SB, Front bearing, K770 DRYCUT/VAC, 2023-04

Figure 1:

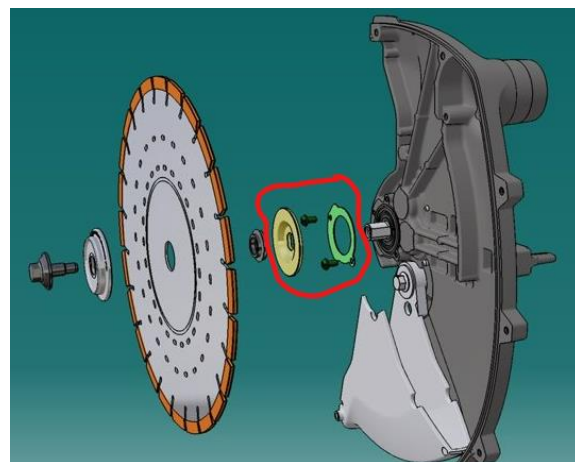
Field reports have shown that the front bearings in the blade guard can move sideways towards the blade. This has been corrected by installing a plate which prevents the bearing from moving (circled in red in figure 1). The plate is installed with two screws in the blade guard. Blade guards on products produced after serial number 20224100001 have the two threaded holes (circled in red in figure 2).

On products with serial number after 20224100001, the SECURING PLATE (536863701), SCREW (578473502) and FLANGE WASHER (590370602) can be installed.
